**ADDENDUM # 10**

**WEGO Transit and Fleet Operations Center Expansion**

**Request for Proposal No: RFP-22-2024-AD**  
**Issue Date of Addendum: January 16, 2025**  
**Proposal Submission Deadline: January 23, 2025 at 2:00 p.m. ET**

**ADDENDUM No.2**

SHEET NAME  
**Typical Roof Details**

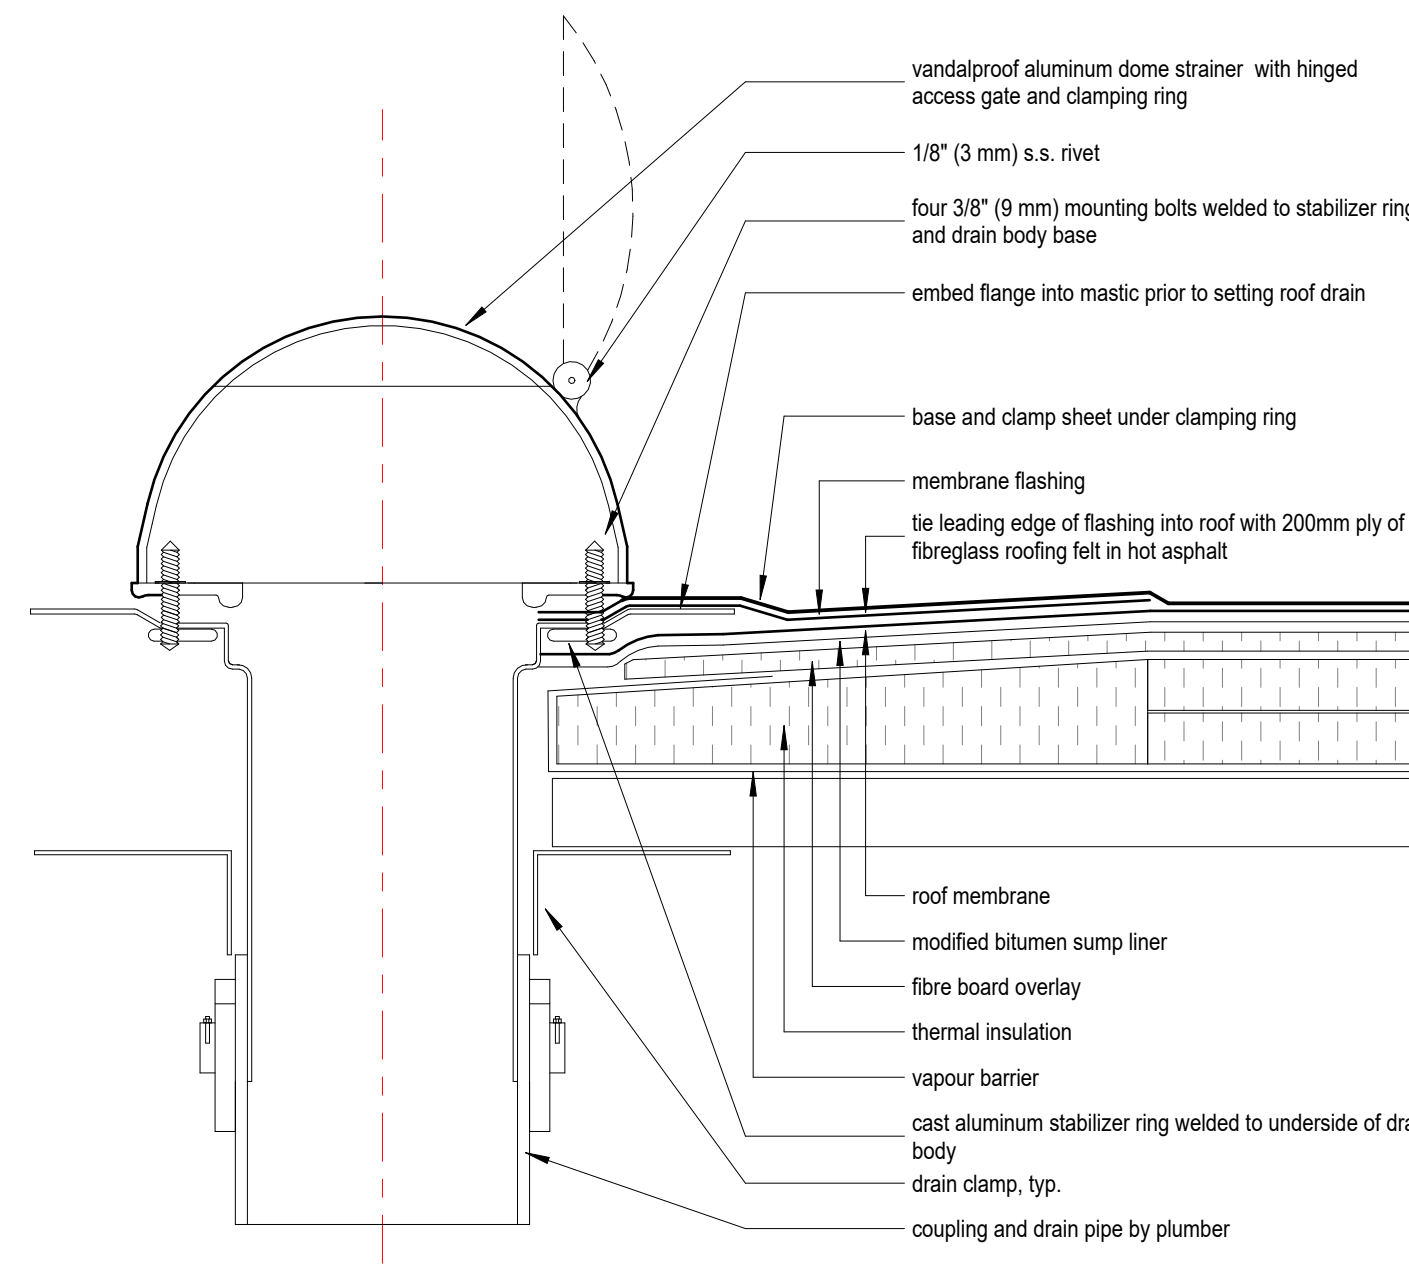
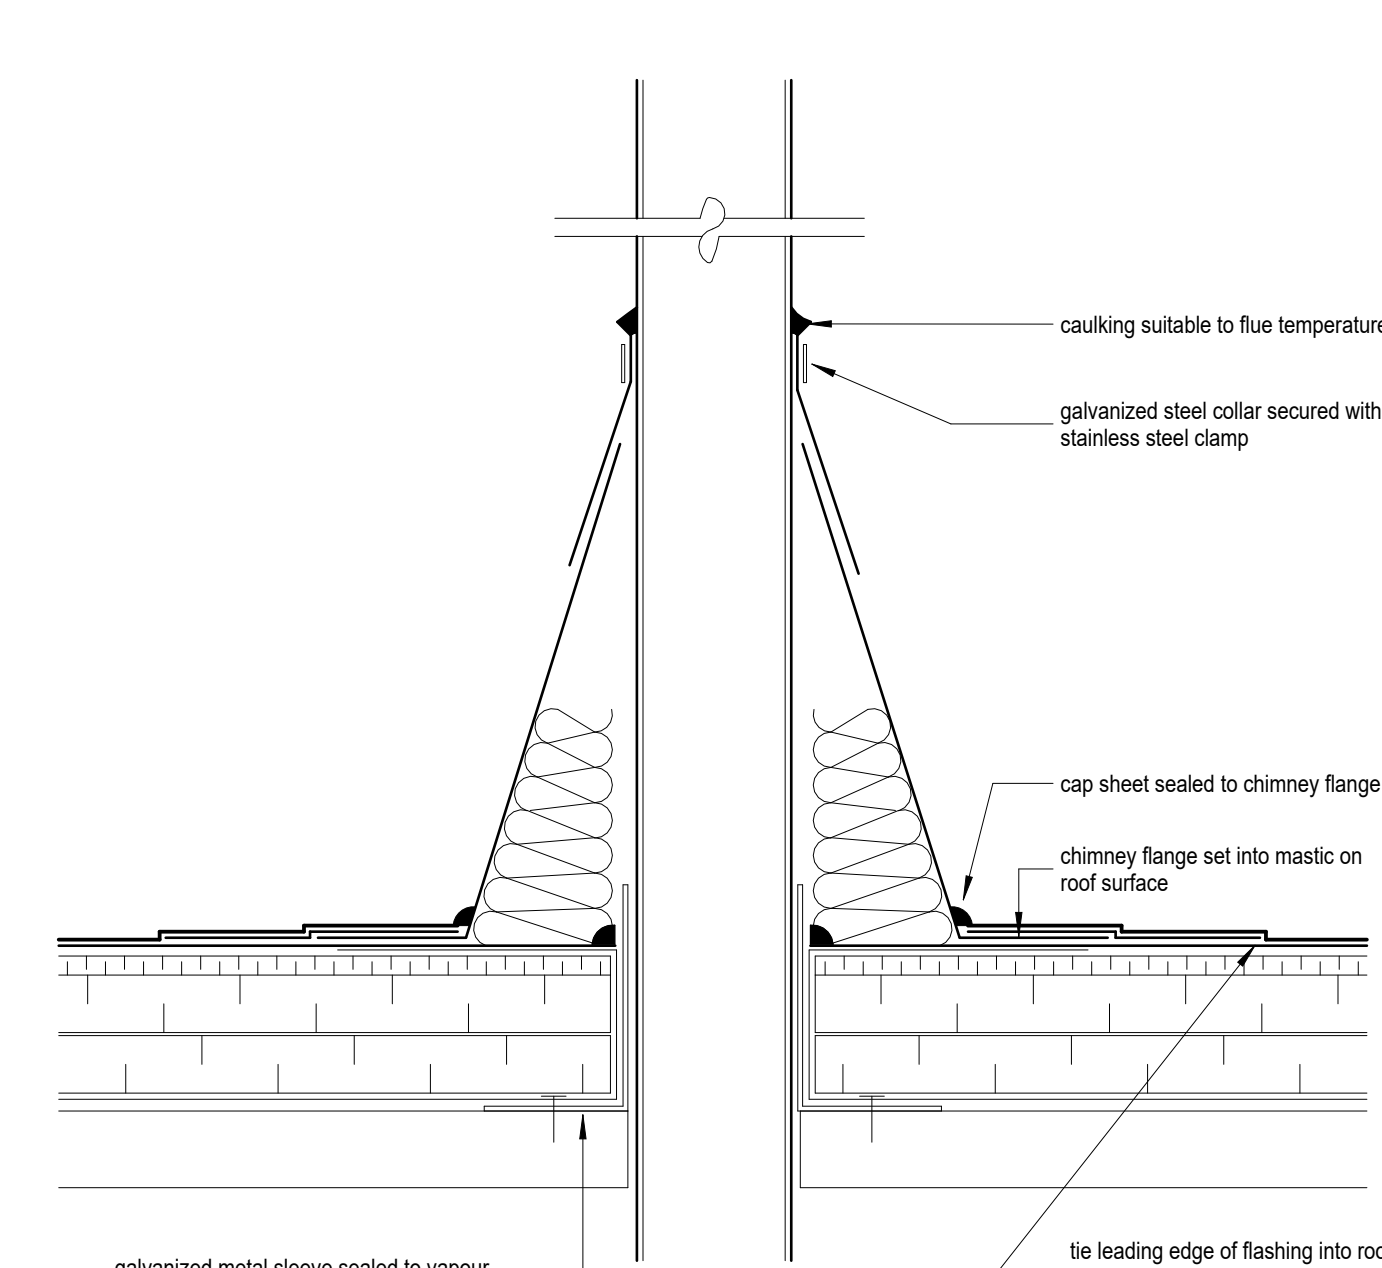
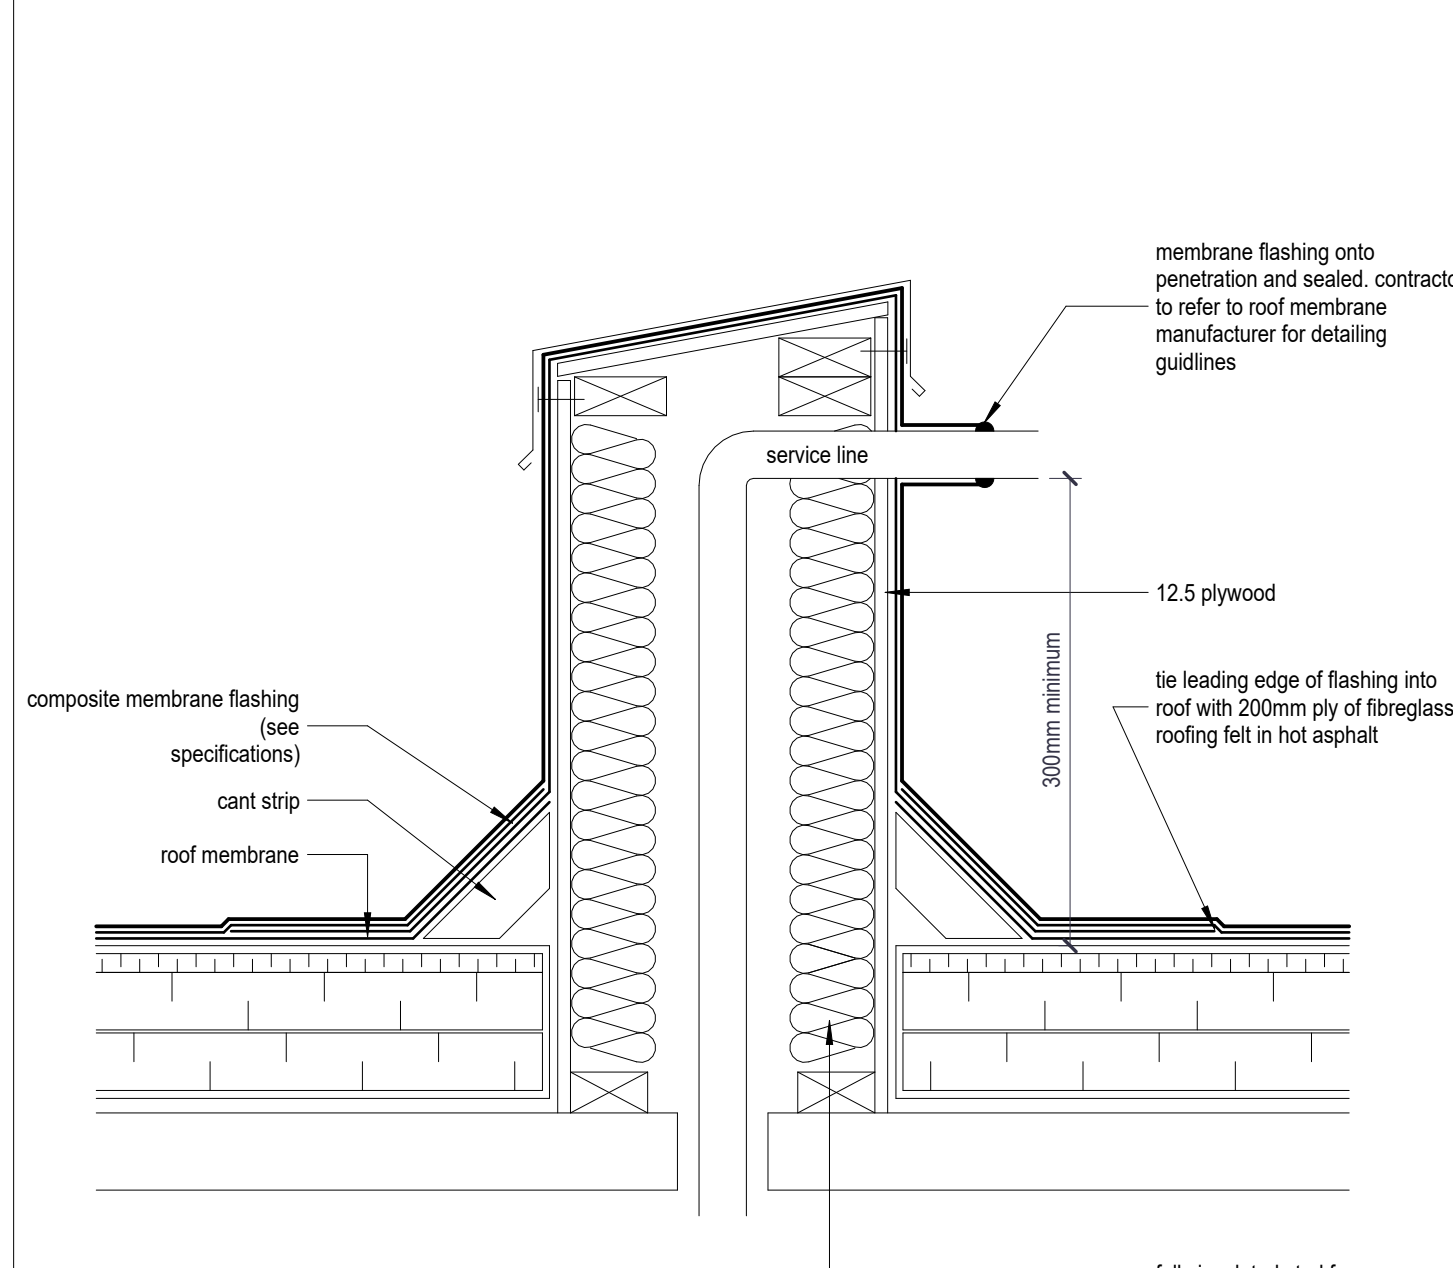
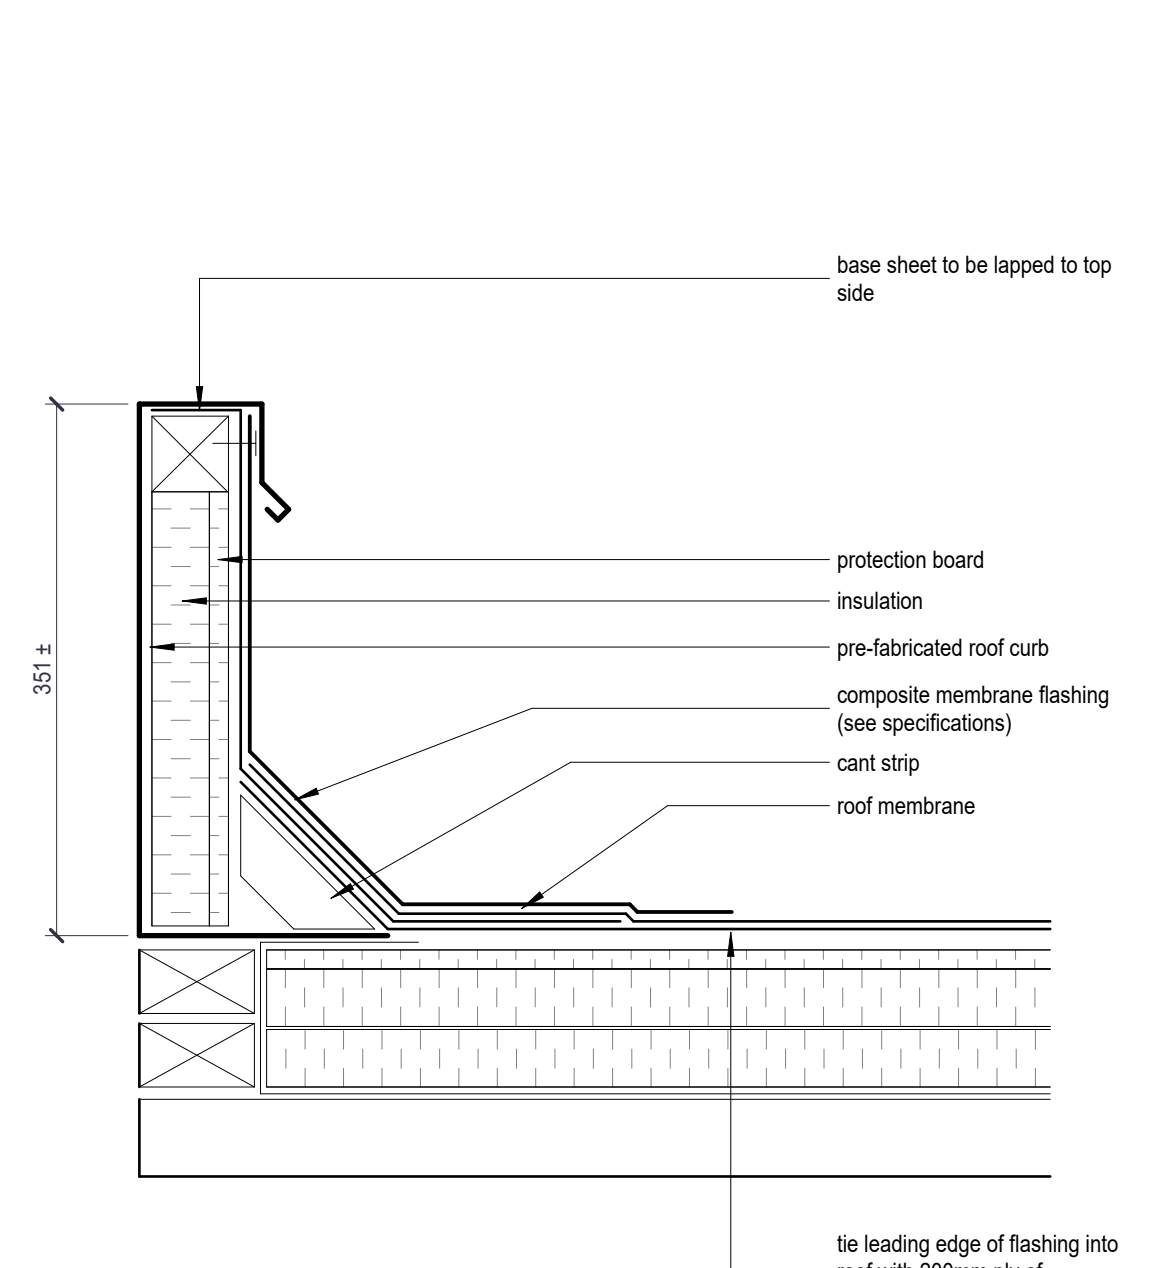
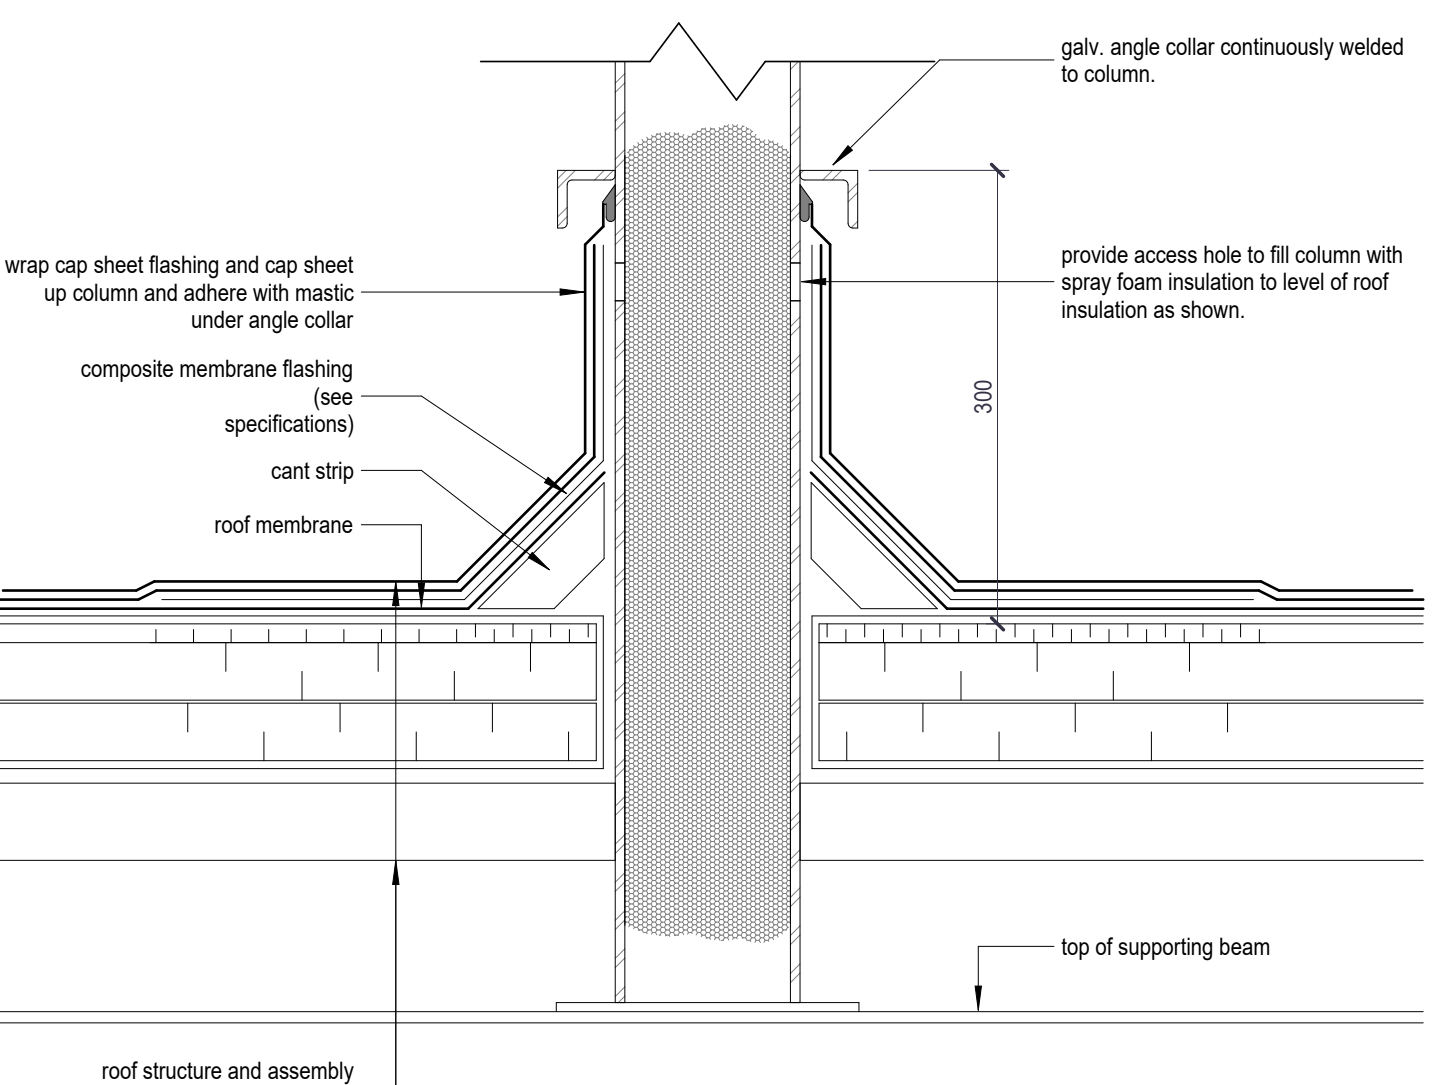
drawings for this scope of work? Additionally, one of the roofers has suggested that mechanically fastened iso takes longer than non-mechanically fastened. Furthermore, the current roofing details and drawings are somewhat vague and generalized. It would be greatly appreciated if you could revise to include more specific callouts and details, particularly for the proper walls/parapets, and divisions of the roof.

**ANSWER:** Refer to A9-200 for roof details added at existing.
